NAVY AVIATION

F/A-18E/F will Provide Marginal Operational Improvement at High Cost

B-260367

This is the Department of Defense (DoD) response to the General Accounting Office (GAO) draft report, "NAVY AVIATION: Decision to Procure F/A-18E/F Should Be Reconsidered," April 15, 1996, (GAO Code 707072), OSD Case 1125. The Department nonconcurs with the report.

Figure 3.1: F/A-18C/D Weapon Stations

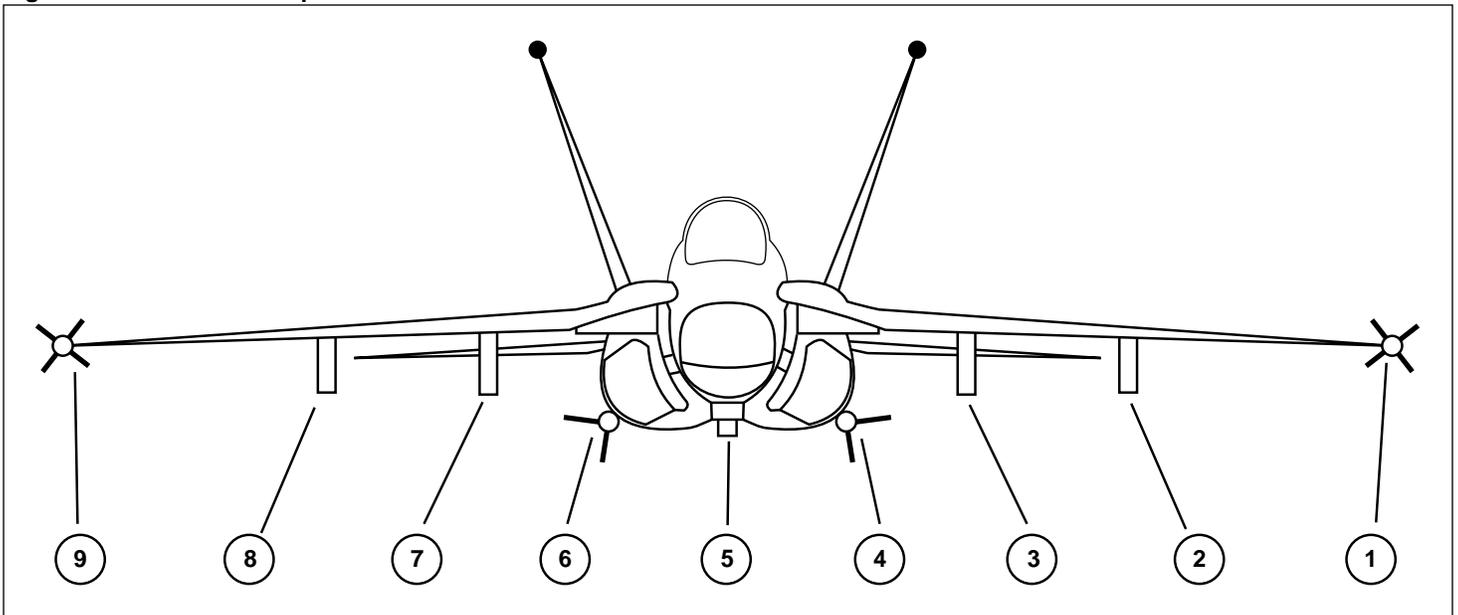
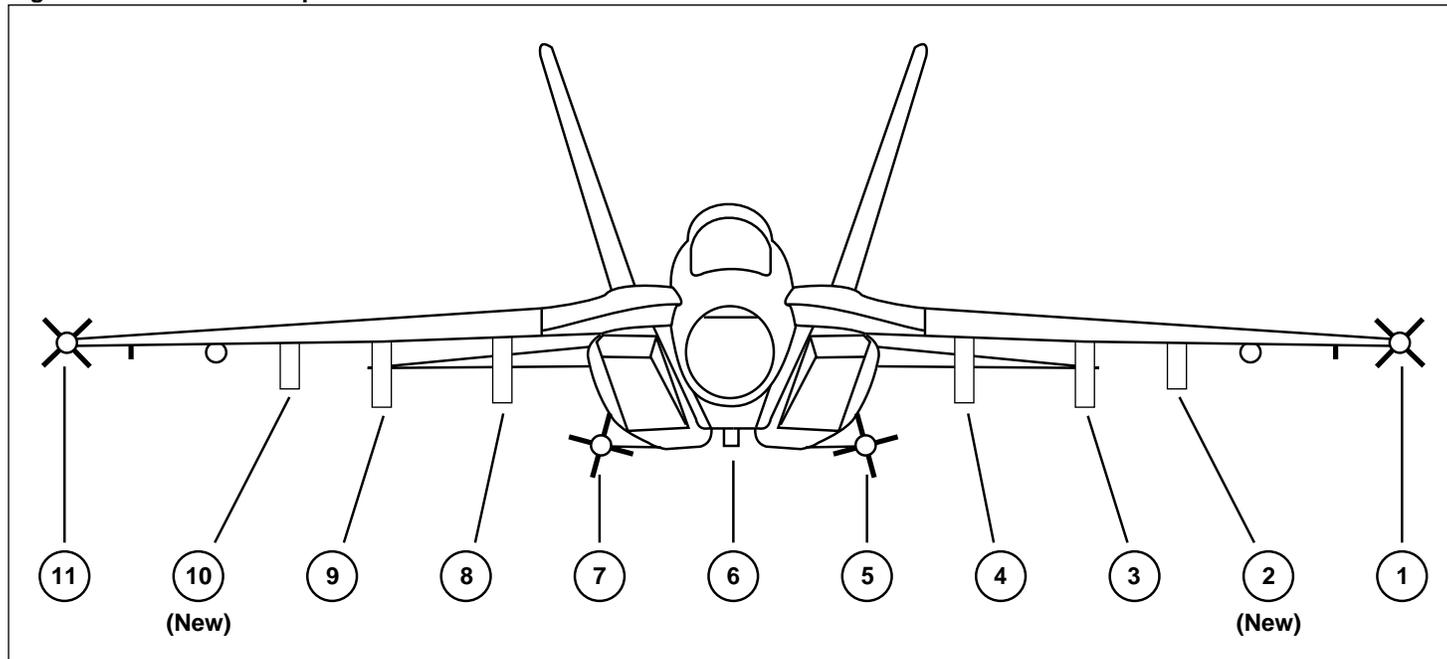
As illustrated in figures 3.1 and 3.2, airframe modifications, such as larger geometrically shaped engine inlets and additional weapon stations, have reduced the critical distance between several F/A-18E/F weapon stations.

The space reduction adversely affects the E/F's capabilities. For example, wind tunnel tests show that an external 480-gallon fuel tank or a MK-84 2,000-pound bomb, carried on the inboard station, will hit the side of the aircraft's fuselage or make contact with other weapons when released. Additionally, according to the representative, the limited distance between the new outboard and mid-board stations, coupled with outboard pylons that are shorter and closer to the wing, will cause problems when releasing large, finned weapons, such as the High-Speed Anti-Radiation Missile (HARM).

The Navy and McDonnell Douglas are studying a number of airframe fixes to correct the airflow problem. They are also studying options that place tactical restrictions on weapon deployments. These options include reducing the number of weapons the E/F carries and reducing the speed the aircraft is flying when the weapons are released.

F/A-18E Offers Enhanced Maneuverability for Fixed Mission Radius

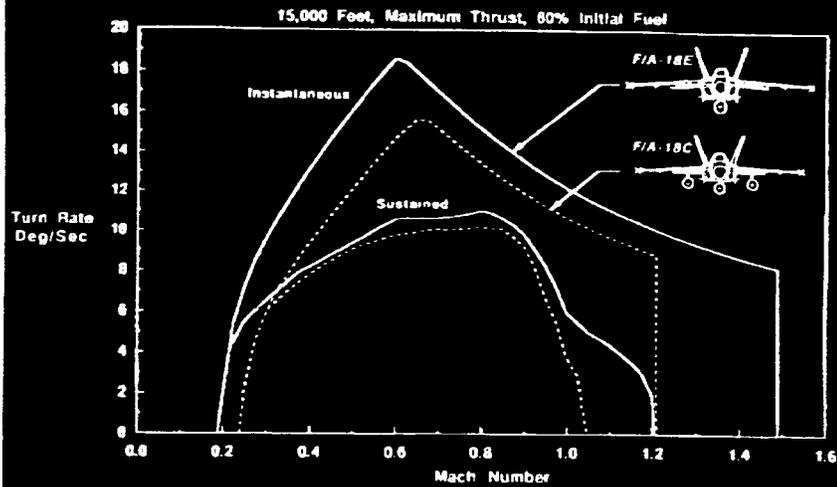
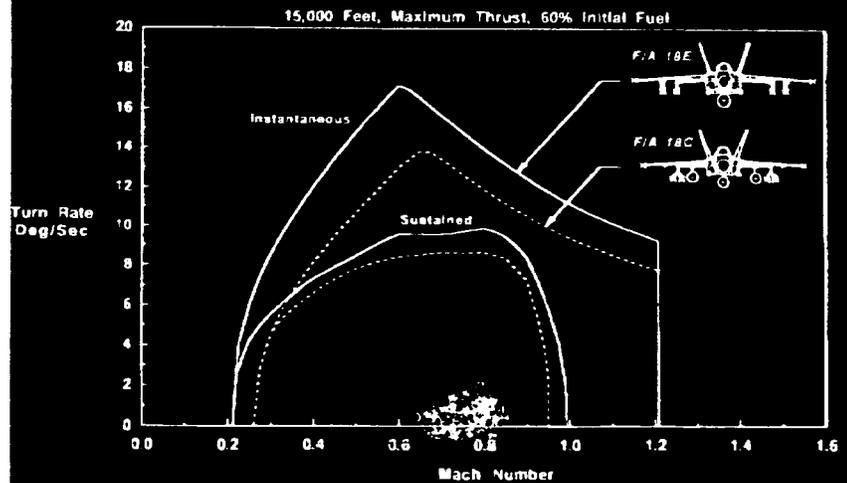
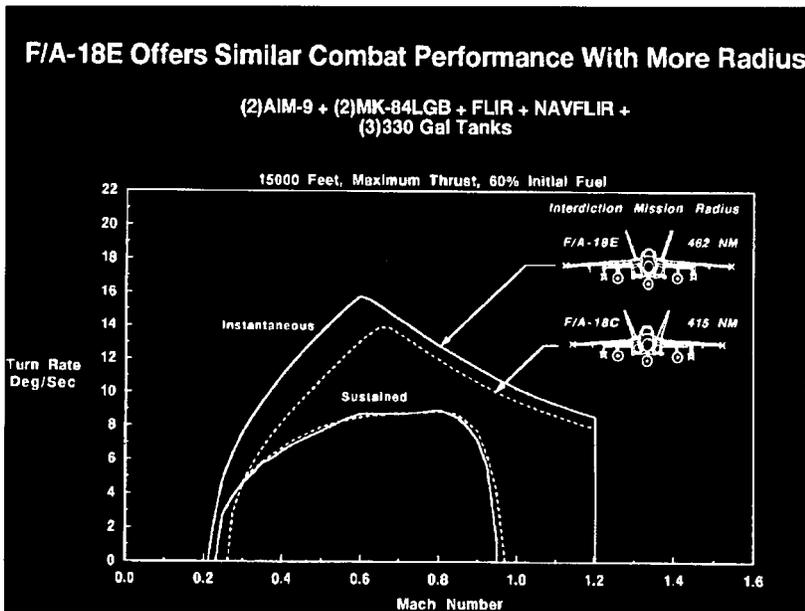
In terms of combat performance, installed thrust is the key factor in comparing the F/A-18E/F to the F/A-18C/D. It is important to understand how installed thrust combines with air vehicle capabilities to deliver fleet capabilities. What the E/F brings to fleet operations is mission flexibility. For example, a real world scenario may call for a mix of F/A-18C/D & F/A-18E/F to perform a Fighter Escort mission with a fixed combat radius of 550 NM. Both aircraft can perform this mission, however, the increased range, capability inherent in the E/F design allows for a more favorable combat load out than the C/D aircraft thus allowing for a more favorable combat performance. The charts below illustrate the improved Turn Rate of the F/A-18E/F over a -402 equipped F/A-18C/D.

In its response, DOD recognized that both the C/Ds and E/Fs can perform their anticipated real world fighter escort with a combat radius of 550nm. The charts that DOD provided as part of its comments show weapons loads for the E/F and C/D that DOD described as real world mission requirements. The charts show the E/F's and the C/D's turn rates with both carrying external fuel tanks. In the comparisons, the C/Ds have more external tanks than the E/Fs (three vs one) and thus will have greater drag. The impact of this drag is shown in both sustained and instantaneous turn rate values. In the charts where the C/D and E/F both have the same number of external tanks, the turn rate performance of the C/D and E/F is almost identical. However, in our report, we used data provided by the Navy to show the combat performance difference between the E/F and C/D without external tanks. According to aviators we discussed this issue with, in a real world mission where the aircraft is threatened and the pilot needs to exercise the aircraft's full flight envelope to survive, they would jettison their tanks. Our comparison isolates and compares the C/D to the E/F in an air-to-air configuration, and based on Navy-provided data comparing C/Ds with E/Fs, the C/D would have the better combat performance characteristics, as we have shown in our report.

Diagram III.I Air Speed Envelope Comparison Between C/D and E/F.

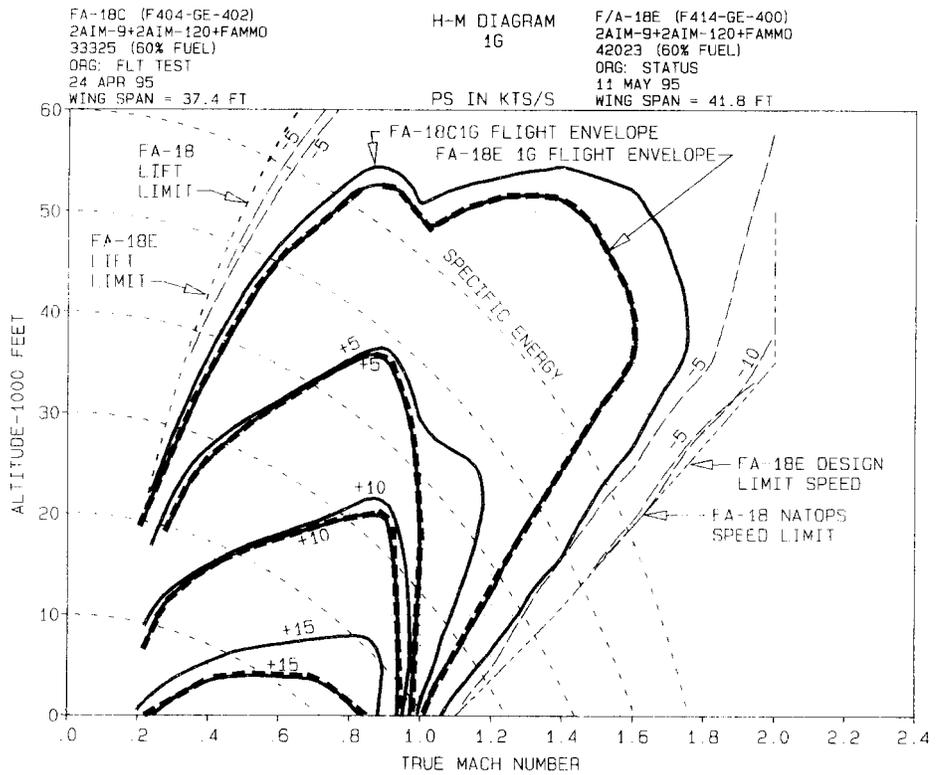
The higher specific excess power for the C/D allows the aircraft to perform better than the E/F. The following diagram, which was provided by NAVAIR, shows that the C/D with the EPE will have a better air speed flight envelope than the E/F.

DOD Figure 1: F/A-18E/F Maximum Possible Carriage of Specified Weapons

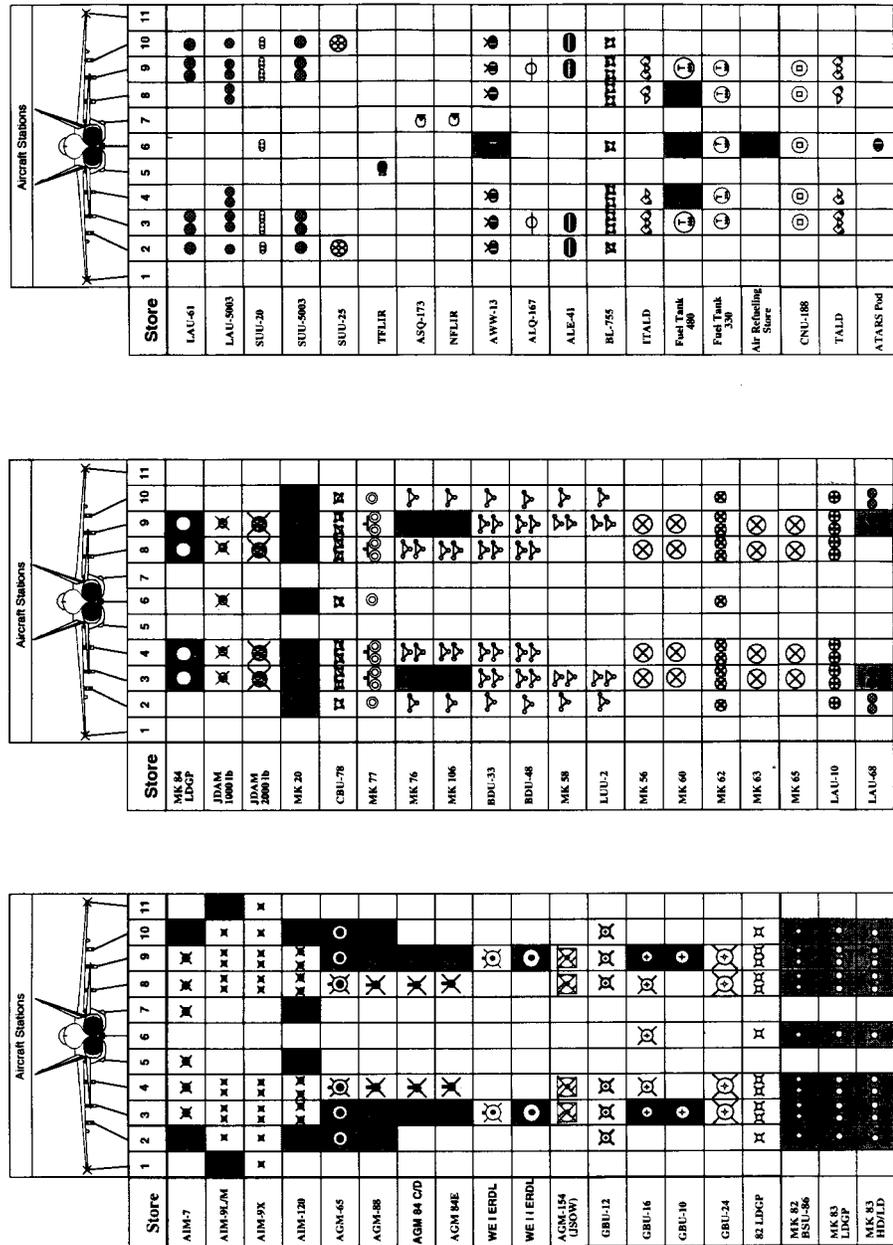
GAO fails to credit the F/A-18E/F's ability to carry the heavier precision weapons while carrying self protection weapons such as HARM, AMRAAM, and Sidewinder on the outboard pylon. The C/D would have to give up use of a heavy store pylon to carry the same protection. The outboard pylons were specifically designed for weapons mix flexibility and self protection, not for the heavier munitions (See Figure 1). The comparison below shows how the E/F carries more heavier precision weapons when going into a high threat area requiring HARM missiles.
